AWAITING RESPONSE
This permit has been placed under review for compliance with the building provisions of the adopted codes and assigned a review status of awaiting response. Please see the review comments on this plan and revise accordingly to complete the review process. Please resubmit a complete set of plans with changes and a narrative as applicable and in accordance with the plan submittal guidelines for the Town of Castle Rock.

SITE DEVELOPMENT PLAN THE BRICKYARD MIXED USE

1 PARKING ALLOCATION PLAN
1" = 60'-0"

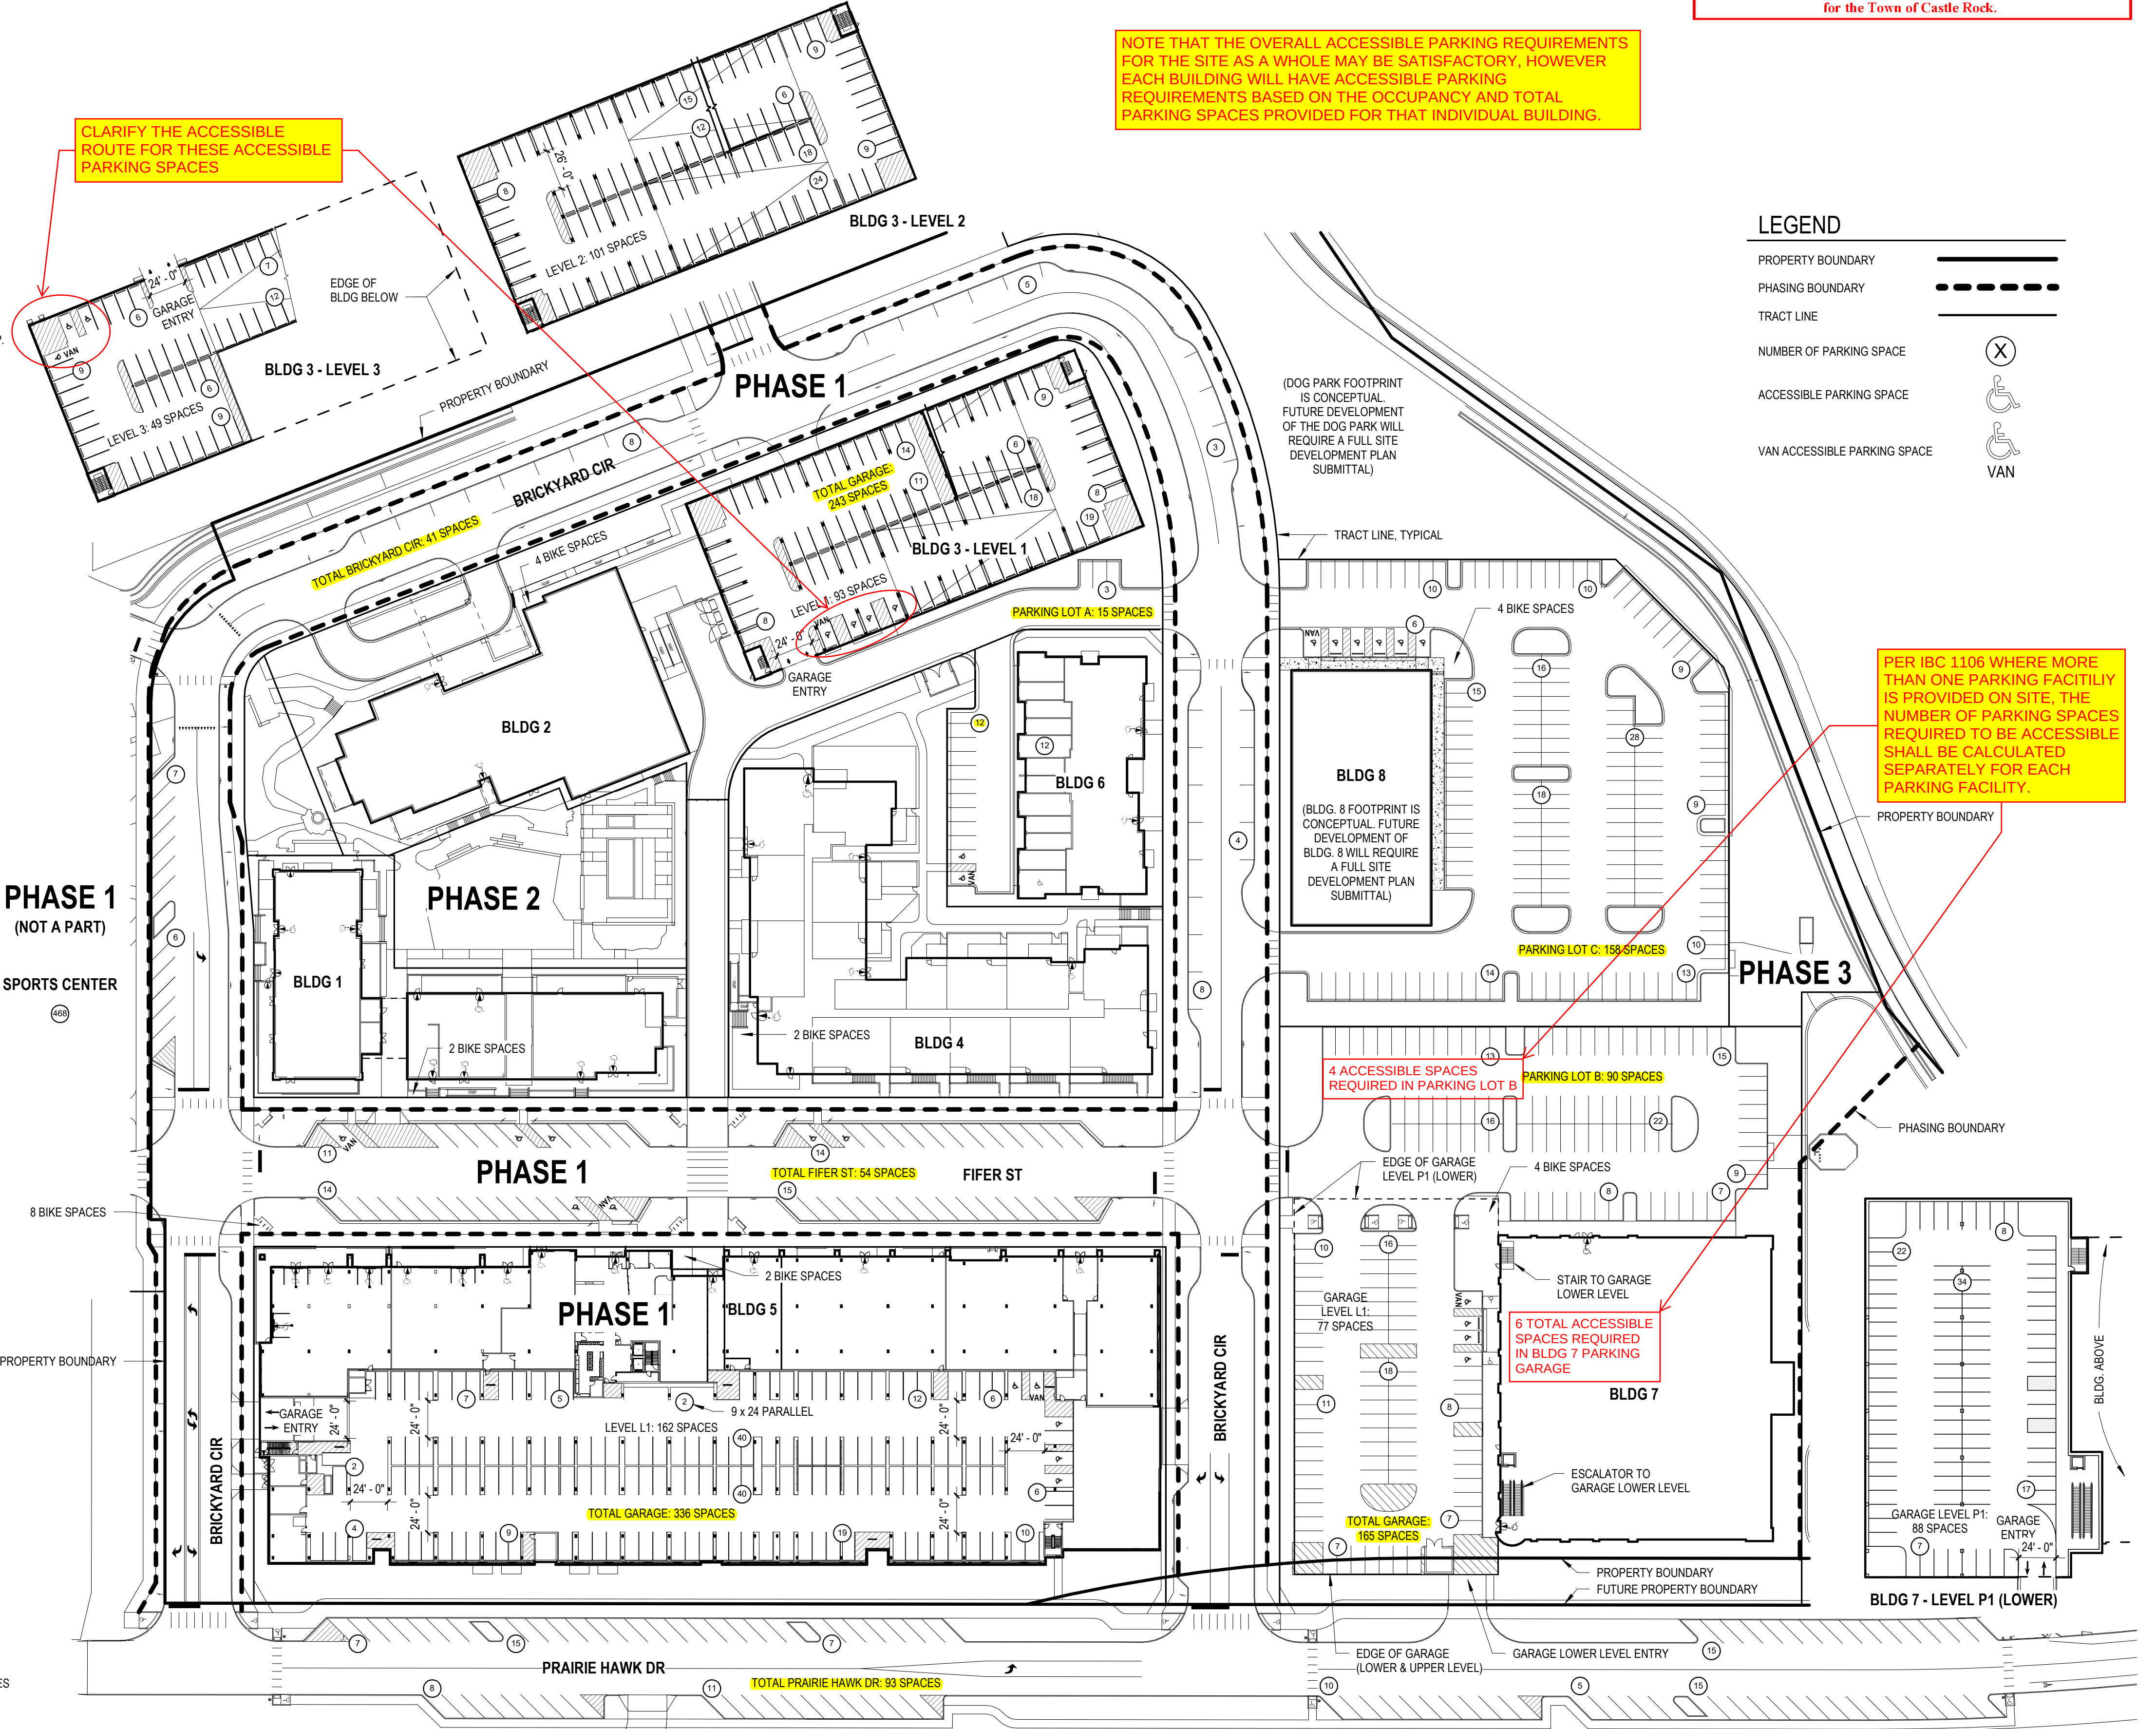
NOTE THAT THE OVERALL ACCESSIBLE PARKING REQUIREMENTS FOR THE SITE AS A WHOLE MAY BE SATISFACTORY; HOWEVER EACH BUILDING WILL HAVE ACCESSIBLE PARKING REQUIREMENTS BASED ON THE OCCUPANCY AND TOTAL PARKING SPACES PROVIDED FOR THAT INDIVIDUAL BUILDING.

CLARIFY THE ACCESSIBLE ROUTE FOR THESE ACCESSIBLE PARKING SPACES

NUMBER OF ACCESSIBLE SPACES REQUIRED FOR THIS INDIVIDUAL PARKING AREA

BASED ON INDIVIDUAL PARKING AREAS A TOTAL OF 38 ACCESSIBLE SPACES ARE REQUIRED WITH 9 TOTAL VAN ACCESSIBLE SPACES. ACCESSIBLE AND VAN ACCESSIBLE SPACES ARE NOT ADDITIVE.

35 SHOWN ON PLAN

PER IBC 1106 WHERE MORE THAN ONE PARKING FACILITY IS PROVIDED ON SITE, THE NUMBER OF PARKING SPACES REQUIRED TO BE ACCESSIBLE SHALL BE CALCULATED SEPARATELY FOR EACH PARKING FACILITY.

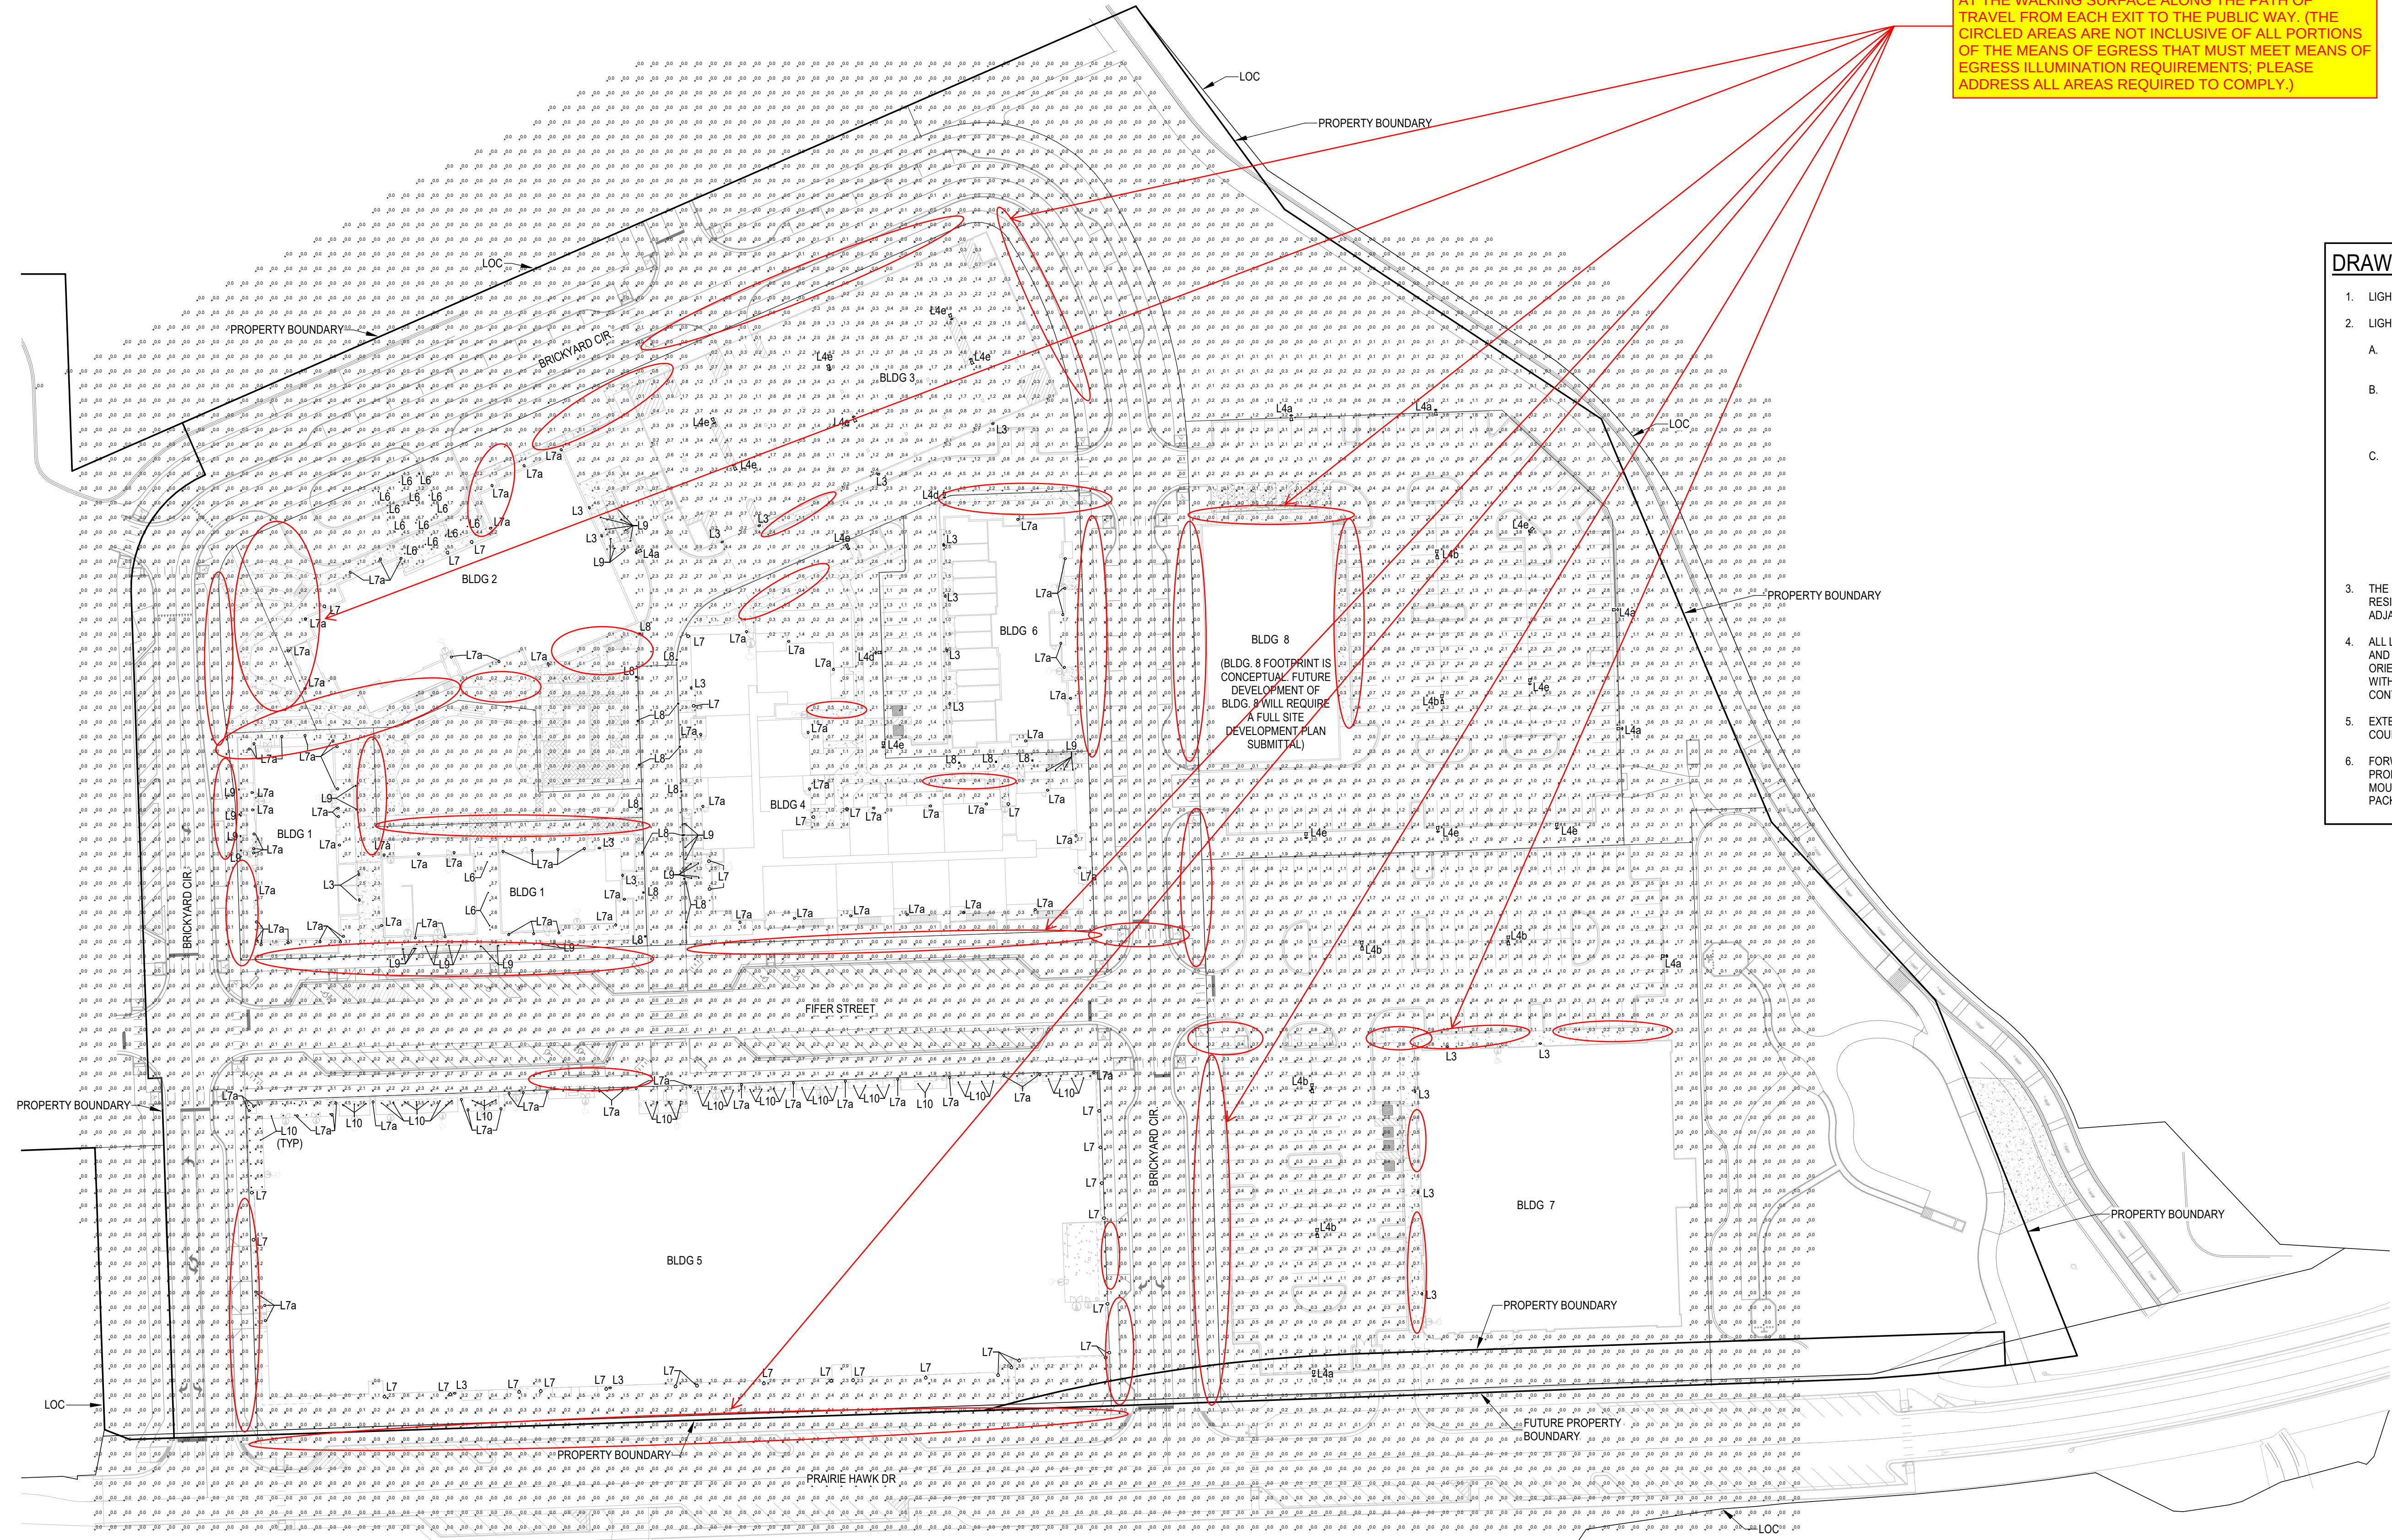
PER IBC 1008.2.1 AND 1008.2.3 MEANS OF EGRESS ILLUMINATION SHALL BE A MINIMUM OF 1 FOOTCANDLE AT THE WALKING SURFACE ALONG THE PATH OF TRAVEL FROM EACH EXIT TO THE PUBLIC WAY. (THE CIRCLED AREAS ARE NOT INCLUSIVE OF ALL PORTIONS OF THE MEANS OF EGRESS THAT MUST MEET MEANS OF EGRESS ILLUMINATION REQUIREMENTS; PLEASE ADDRESS ALL AREAS REQUIRED TO COMPLY.)
